International Aero Engines SERVICE BULLETIN

NACELLE - EXHAUST - COMMON NOZZLE ASSY - BIFURCATION FAIRING -MODIFICATION OF

V2500-D5

V2500-NAC-78-0116 Page 1 of 13

CNA Bifurcation Fairing Trim Figure 1

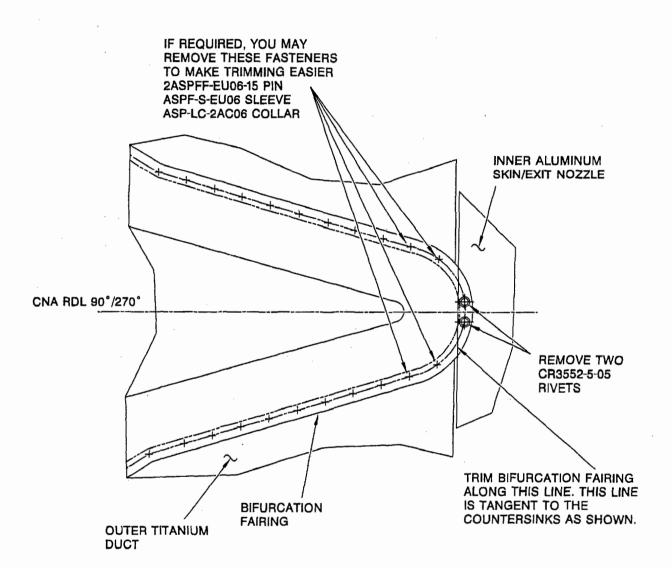
Cracking may exist at the aft-most fastener hole locations of the CNA Bifurcation Fairing.

The changes incorporated in this Bulletin are intended to eliminate cracking of the fairing at the aft-most fastener locations.

- B. Modification Instructions Common Nozzle Assy
 - (1) Find the CNA bifurcation fairing inside the CNA at the 90 degree radial location.
 - (2) Use a (0.156in.) (3,962 mm) diameter drill and remove the two aft-most CR3552-5-05 rivets. Refer to Figure 1.
 - (3) If necessary, you may remove the four adjacent ASPFF-EU06-15 pins, ASPF-S-EU06 sleeves, and ASP-LC-2AC06 collars for access before you trim the fairing. Refer to Figure 1.

(4) Trim the aft portion of the bifurcation fairing as shown in Figure 1.

CNA Bifurcation Fairing Trimmed Edge Sealing and Fastener Location Figure 2

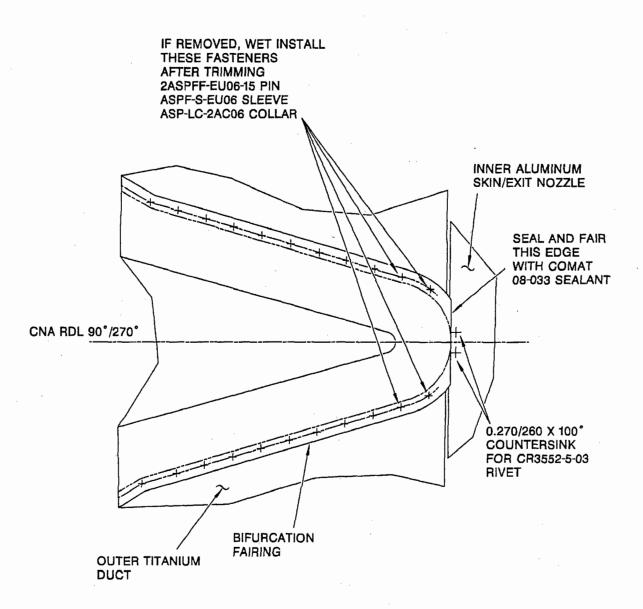
- (5) Mix the conversion coating in a ratio of 0.4-0.5 ounce conversion coating (CoMat 07-106) to 1.0 gallon of demineralized water.
- (6) Apply the conversion coating to the trimmed area on the bifurcation fairing for two to five minutes. Keep the surface wet with fresh solution. Do not allow the solution to dry.
- (7) Rinse the conversion coating from all surfaces with clean water and dry with a lint free cloth (CoMat 02-099).
- (8) Install the fasteners as follows:
 - (a) Countersink the two existing rivet holes in the exit nozzle to 0.270in. (6,858 mm) +0/-0.010in. (0,254 mm) diameter by 100 degrees.

- (b) Mix the primer base (CoMat 07-071), primer converter (CoMat 07-067), and thinner (CoMat 07-066). Refer to the manufacturer's instructions.
- (c) Wet install the two CR3552-5-03 rivets with the primer mix to fill the existing rivet holes. Refer to Figure 2.
- (d) If previously removed, wet install the 2ASPFF-EU06-15 pins, ASPF-S-EU06 sleeves, and ASP-LC-2AC06 collars with primer mix as shown in Figure 2.

(9) Seal and fair the trimmed edges of the bifurcation fairing as follows:

- (a) Apply the primer (CoMat 08-032) to the trimmed edges. Refer to the manufacturer's instructions.
- (b) Mix the sealant (CoMat 08-033). Refer to the manufacturer's instructions.
- (c) Apply the sealant (CoMat 08-033) to the trimmed edges. Remove any unwanted sealant with a lint free cloth (CoMat 02-099). Refer to Figure 2.
- (10) Do modification instruction steps (2) through (10) above for the CNA Bifurcation Fairing at the 270 degree radial location.
- C. Post-requisite Instructions
